DART SERVICE INSTRUCTION

TO AMEND INSTALLATION INSTRUCTIONS D350-591 REV. G
AND INSTRUCTIONS FOR CONTINUED AIRWORTHINESS ICA-D350-591 REV. 3
REF TCCA STC: SH92-6
REF FAA STC: SH967NE

TO PROVIDE AN OPTIONAL CUSHION KIT TO BE INSTALLED ON THE D350-591-111A/-113/-115/-117A/-119 Heli-Access-Step™ (THE D2856-400-720 ABRASION STRIP IS REPLACED WITH THE D3595-200-300 CUSHION).

FIGURE 32-9: Crosstube Attachment

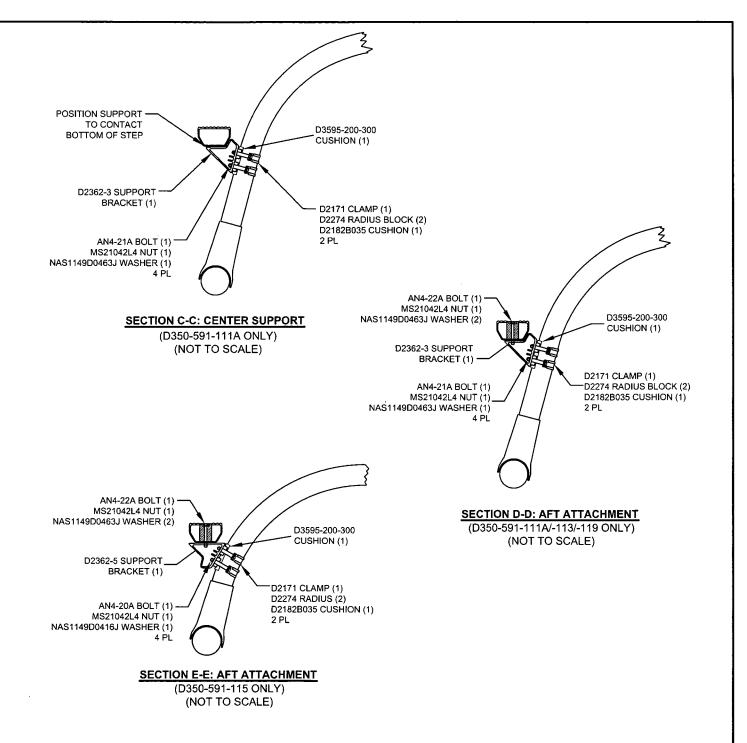
- 1. REMOVE THE STEP PER ICA-D350-591 SECTION 32.2
- 2. REMOVE THE D2856-400-720 ABRASION STRIP PER ICA-D350-591 SECTION 32.4
- 3. POSITION THE D3595-200-300 CUSHION AS INDICATED ON SHEET 3 OR 4 (AS APPLICABLE) OF THIS SERVICE INSTRUCTION.
- 4. REINSTALL THE STEP PER ICA-D350-591 SECTION 32.1 AS APPLICABLE USING THE NEW HARDWARE PROVIDED AS SHOWN ON SHEET 3 OR 4 (AS APPLICABLE) OF THIS SERVICE INSTRUCTION.
